Surveillance Report

Package / Item:	Bascule span to the Railway bridge "Jernbanebroen over Limfjorden"
Supplier:	MT Højgaard
Purpose of visit:	Production & Quality Surveillance – Steel structure Visit No. 3
Location / Address:	Tarcon Tarnobrzeg Poland

Date of Visit / Review: 2012-09-05 to 2012-09-06

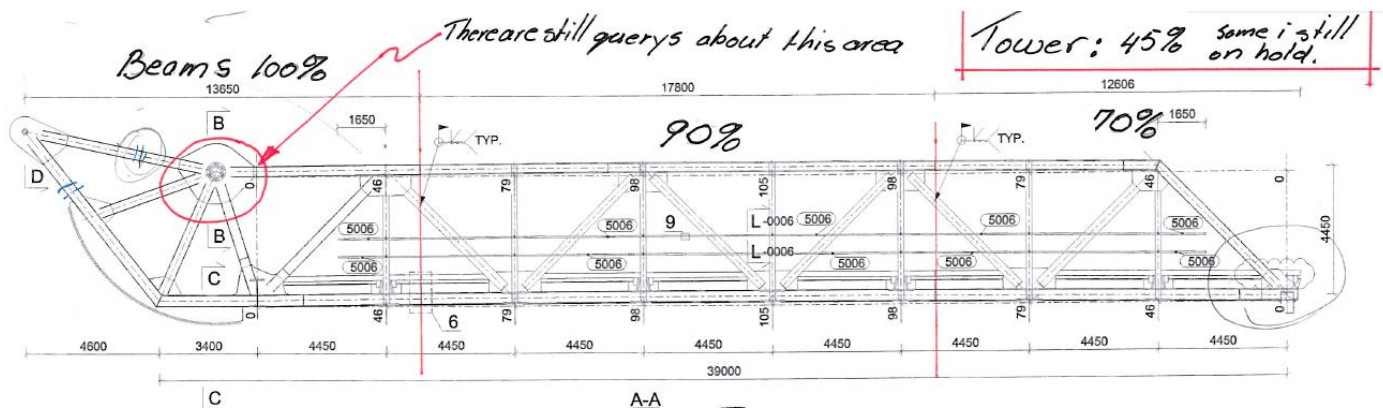
MT Højgaard showed Rambøll a drawing with stage of progress. Rambøll estimate that production is about 2-3 weeks delayed compared to the time schedule version 7. It is important that MT Højgaard makes a new time schedule that is updated, because the schedule is used to coordinate with other projects on the site location. Svend Elias from MT Højgaard promised that a new time schedule will be forwarded to Rambøll the 06-09-2012.

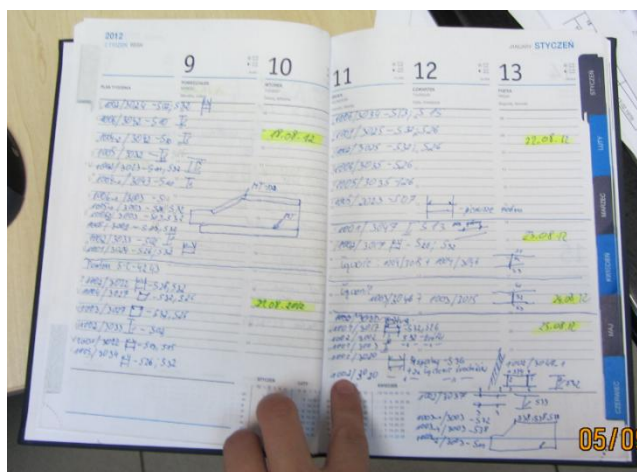
At the shop Rambøll found traces after MPI testing on both stump and fillets welds. Tarkon showed Rambøll logbooks and drawings showing which element that was tested together with an inspection report. Rambøll emphasized the importance of testing on mixed lots. Based on a trial test Rambøll has no further comments.
